18 June 2021

Re: DEVELOPMENT APPLICATION NO. DA/642/2020 – 11-19 FRENCHMANS ROAD, RANDWICK
APPLICANT'S RESPONSES TO COUNCIL REQUEST FOR INFORMATION AND DESIGN
EXCELLENCE PANEL COMMENTS
AMENDED DEVELOPMENT APPLICATION AND ADDENDUM STATEMENT OF ENVIRONMENTAL
EFFECTS

Table 1: List of Amended Documents and Appendices References

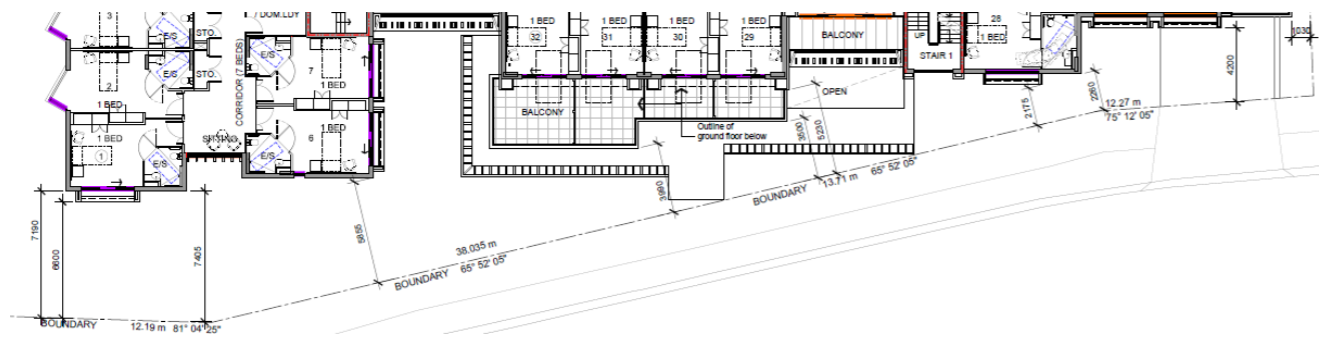
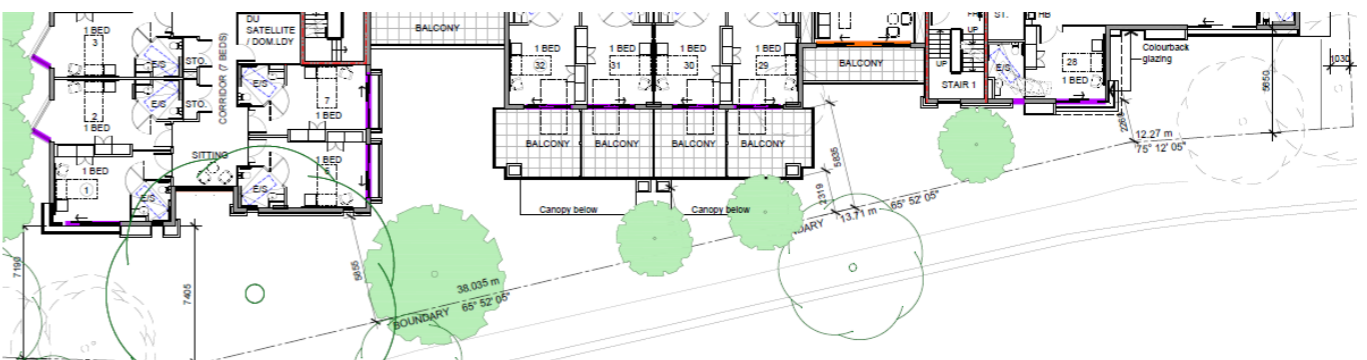
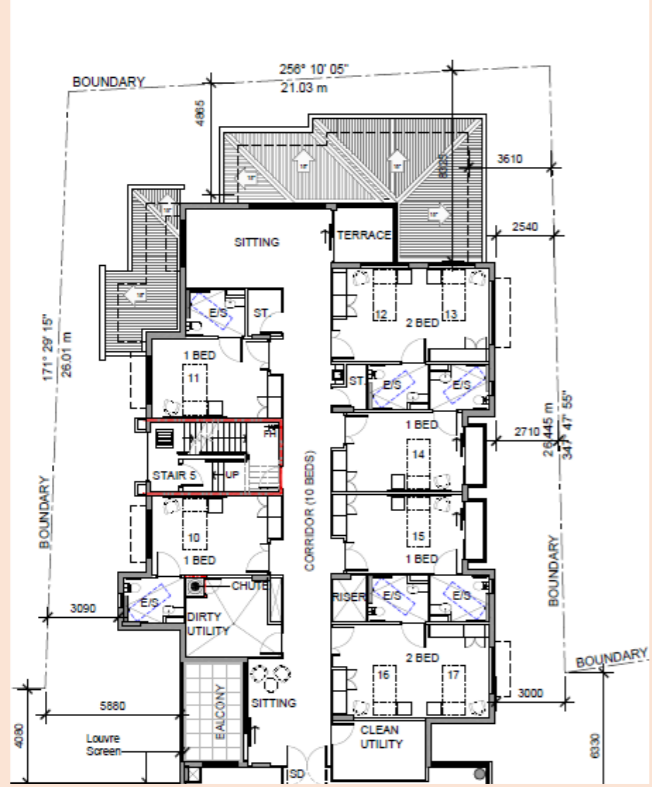
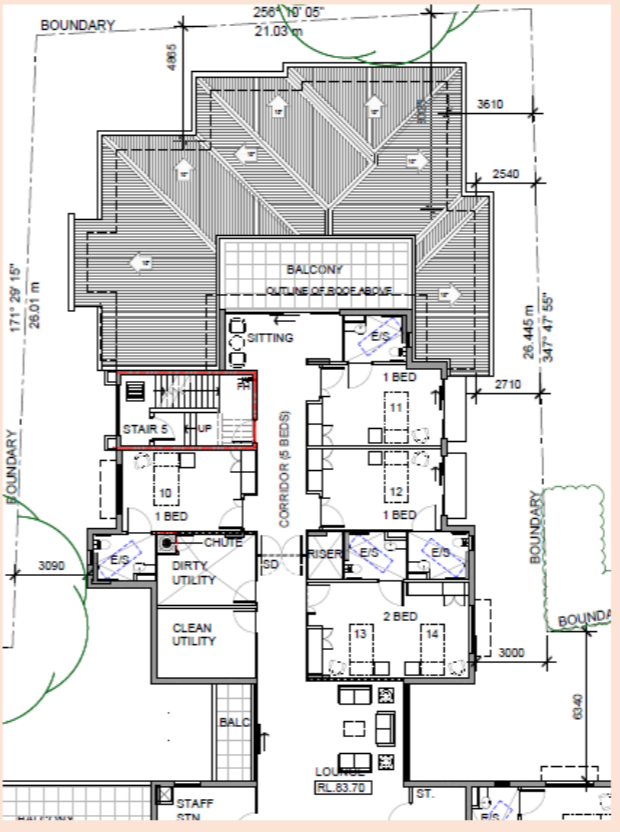
9	<p>DA07 Second Floor Level</p> <p>Northern “wing” of proposed building – original layout</p> 	<p>DA07 Rev B Second Floor Level dated 1 June 2021</p> <p>Northern wing of proposed building now recessed from view / bulk shifted away from McLennan Avenue includes enclosed balcony, roof area pitched / non-trafficable, eastern boundary to 25 McLennan Avenue and western boundary to 27 McLennan Avenue increased, replanning above terraces connected on the ground floor level</p>

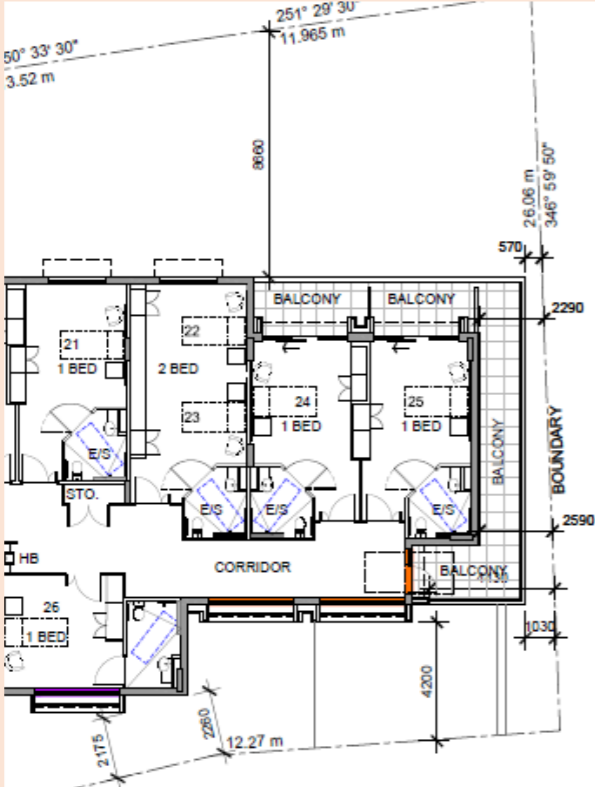
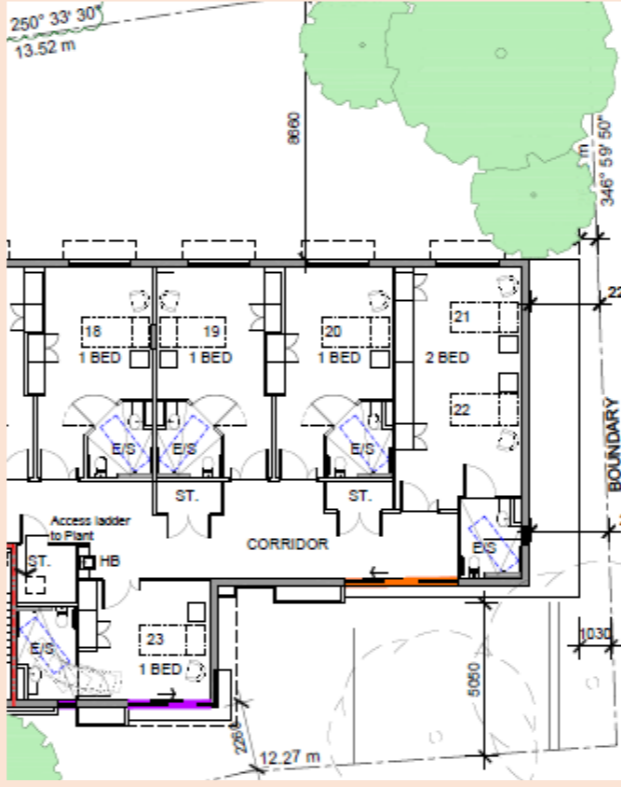
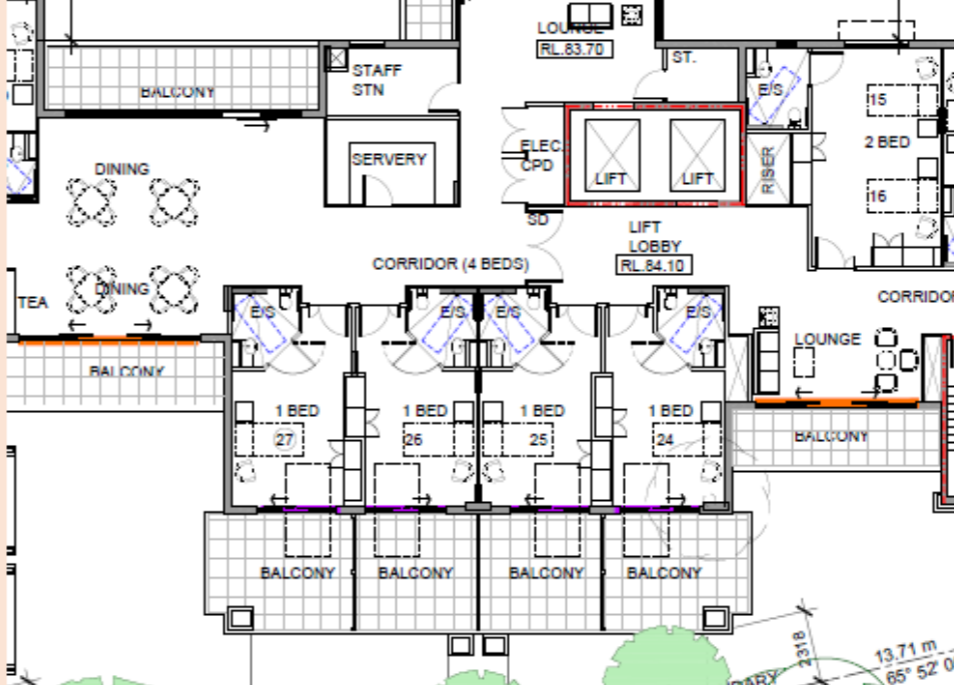
<div> <div>R O W</div> <div>Original Architectural Design</div> </div>	<div> <div>Amended Architectural Design</div> </div>
<div> <div>Eastern “wing” of proposed building – original layout</div>  </div> <div> <div>Central core layout</div>  </div>	<div> <div>Eastern wing balconies removed</div>  </div> <div> <div>Central core layout – introduced balconies to Frenchmans Road elevation</div>  </div>

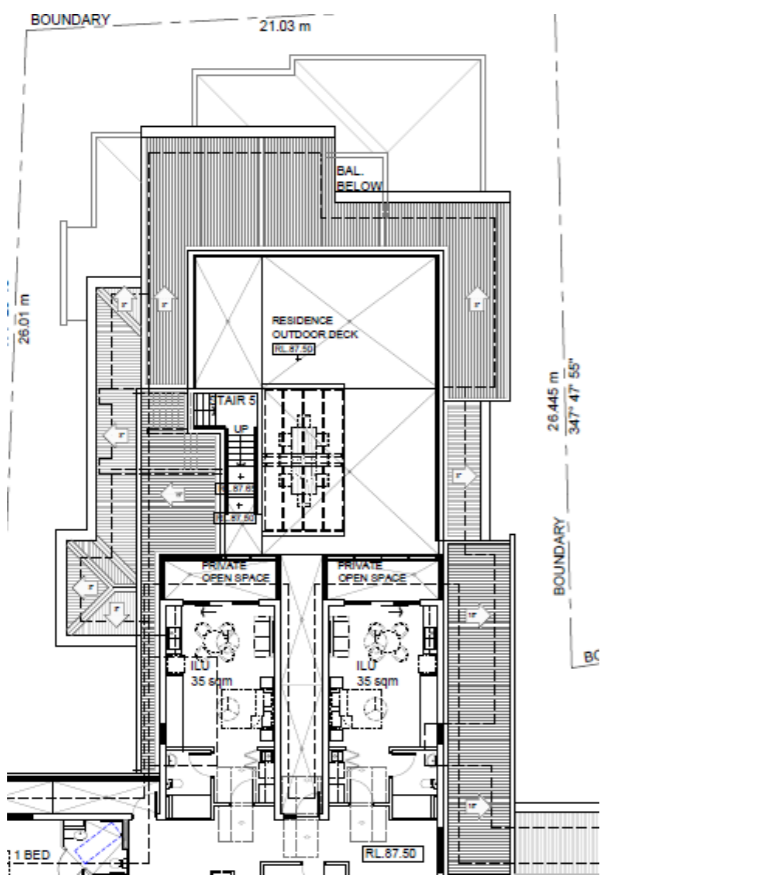
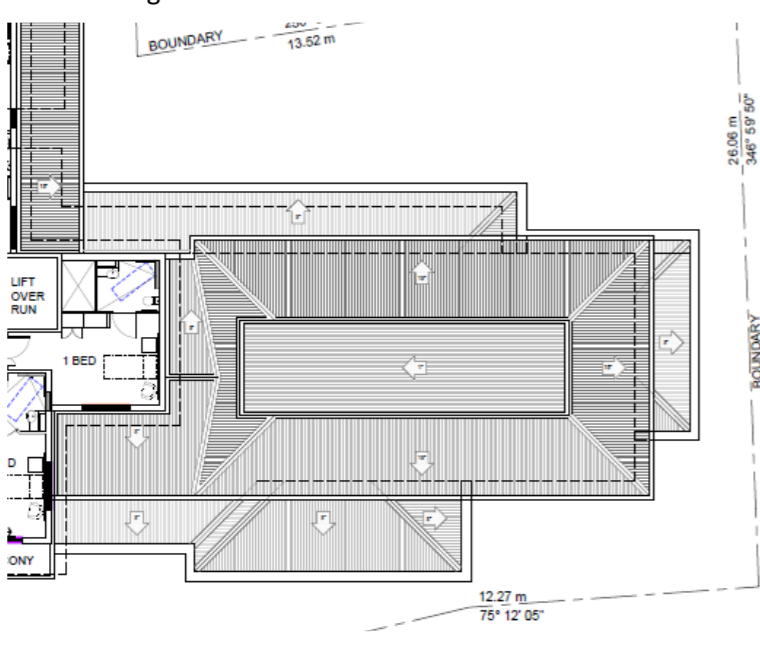
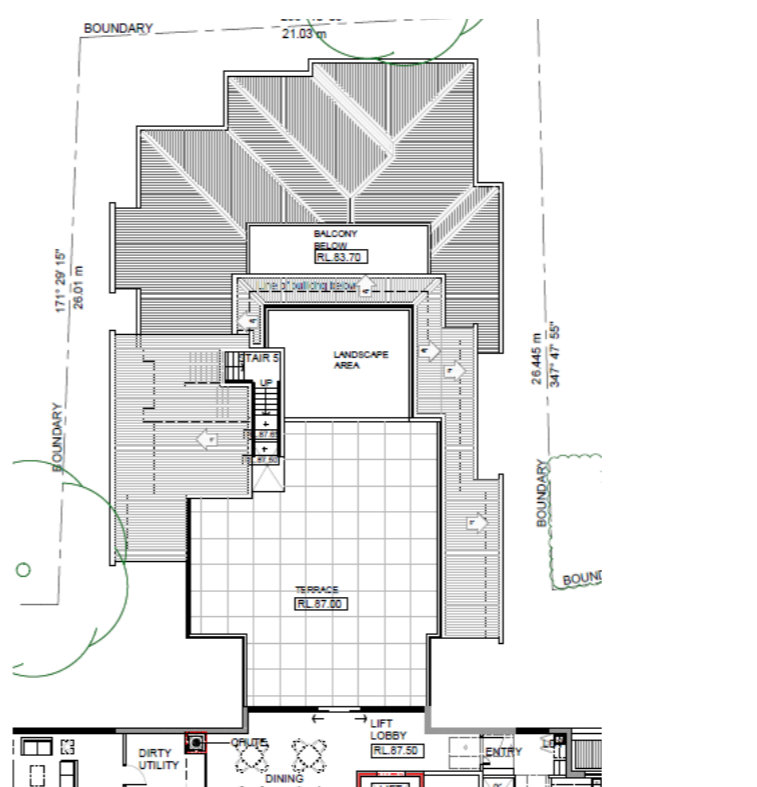
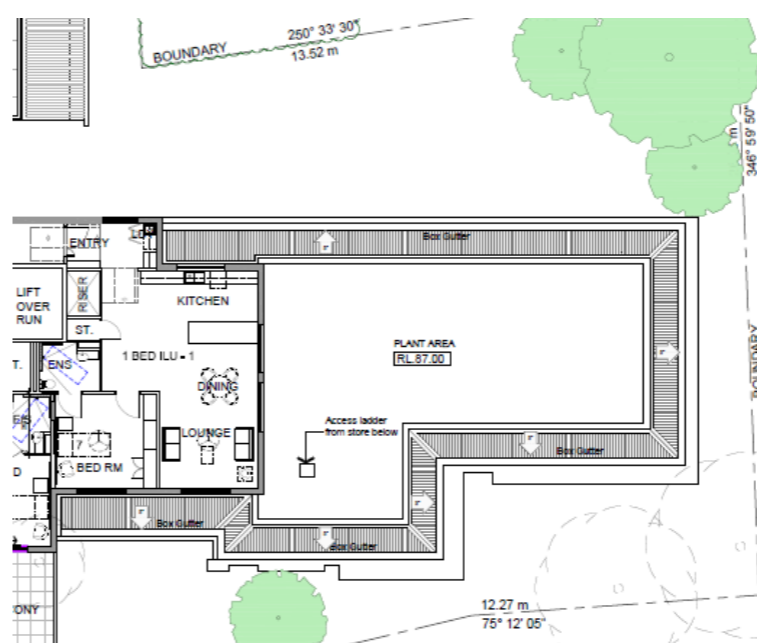
R O W	Original Architectural Design	Amended Architectural Design
1 0	<p>DA08 Third Floor Plan</p> <p>Northern wing</p>  <p>Eastern wing</p> 	<p>DA08 Third Floor Plan Rev B dated 1 June 2021</p> <p>Northern wing – ILUs removed from this section and repositioned to create enlarged roof terrace with landscaped planter bed and amended roof / non-trafficable area surrounds as requested by DEP, increased setbacks from eastern and western boundaries</p>  <p>Eastern wing – inclusion of ILU-1, deleted pitched roofs provision of plant area, provision of parapet surround for acoustic barrier</p>

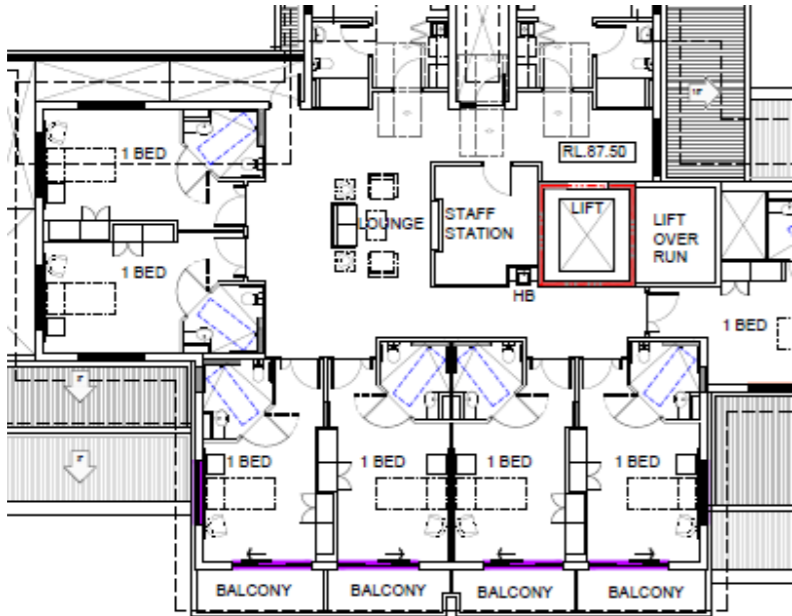
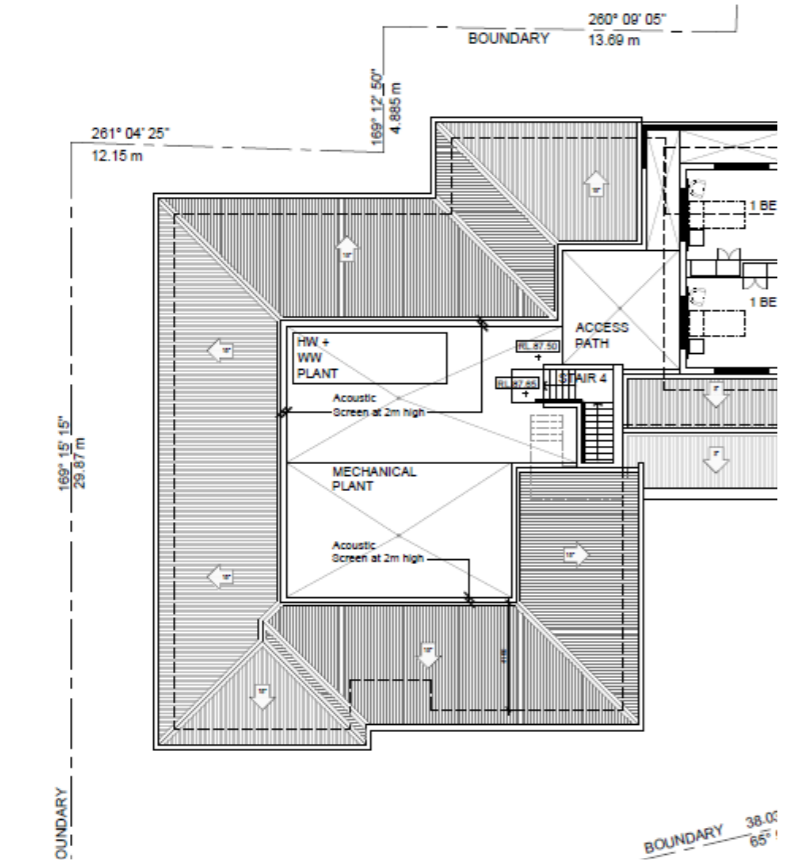
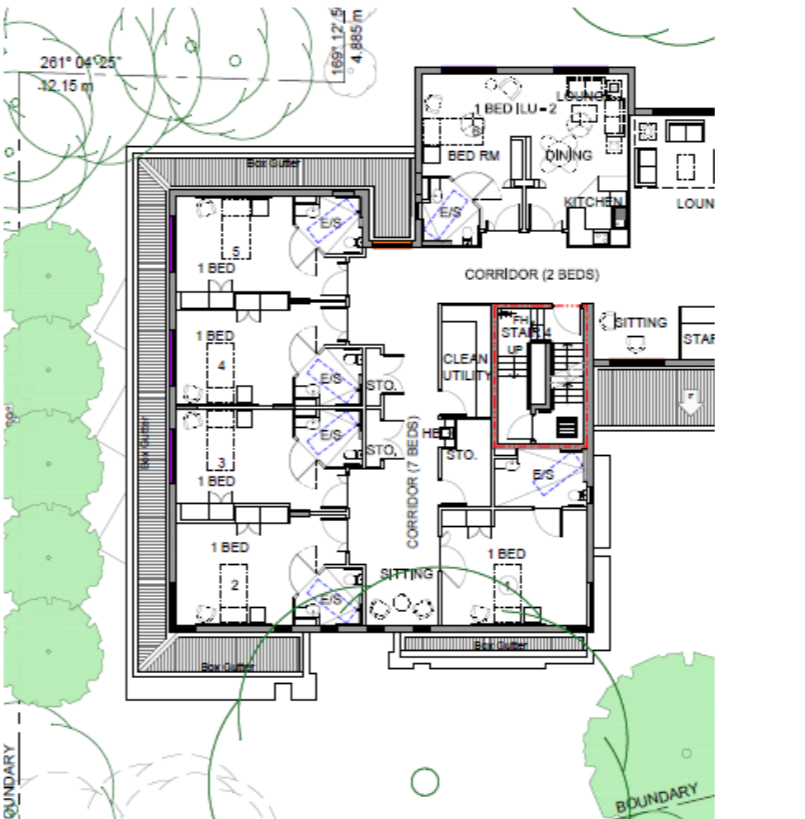
R O W	Original Architectural Design	Amended Architectural Design
	<p>Central core</p> 	<p>Central core – inclusion of balconies to Frenchmans Road elevation</p> 
	<p>Western wing</p> 	<p>Western wing – deletion of plant area, inclusion of 5 rooms which are off-set from the level below by 2m, and ILU-2</p>

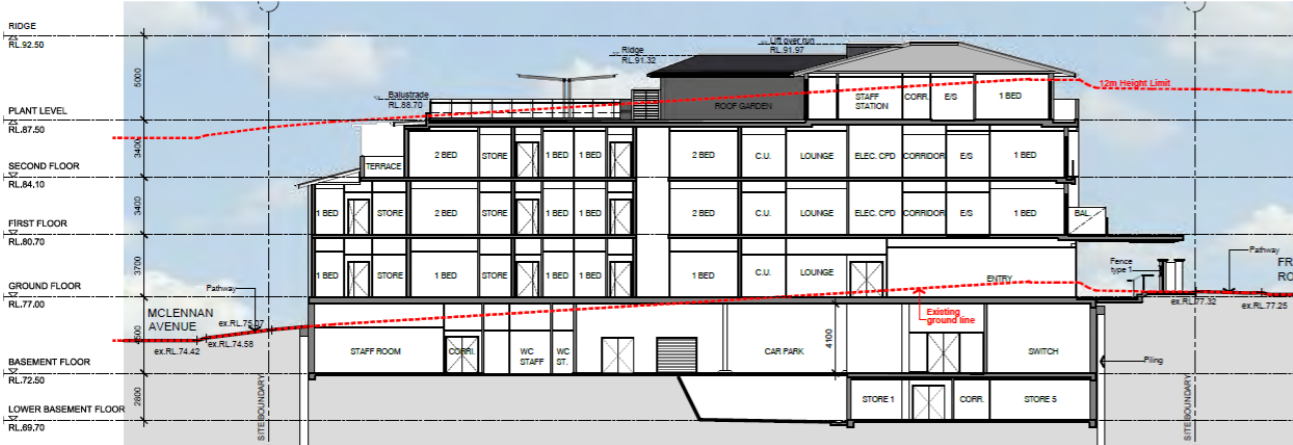
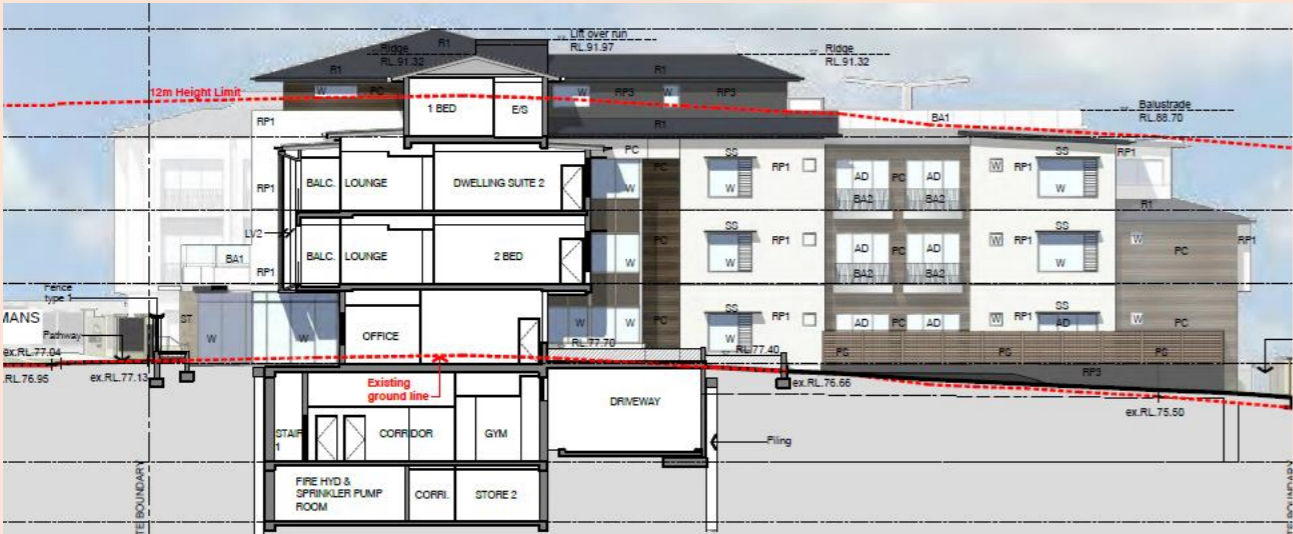
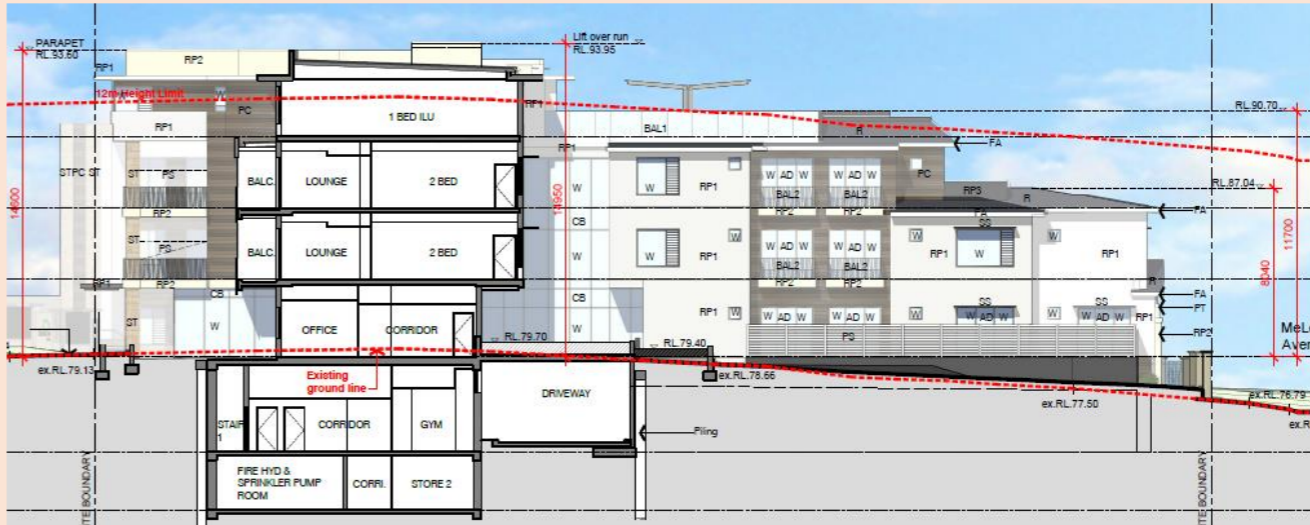
ROW	Original Architectural Design	Amended Architectural Design
	<p>Section C</p> 	<p>Section C – flat roof instead of hipped roof (removed), landscape bed on roof level added, increased setback to upper level 3 from McLennan Avenue</p> 
1	DA11 Sections (D, E, F & G)	DA11 Sections (D, E, & F) Rev B dated 1 June 2021
3	<p>Section D</p> 	<p>Section D</p>
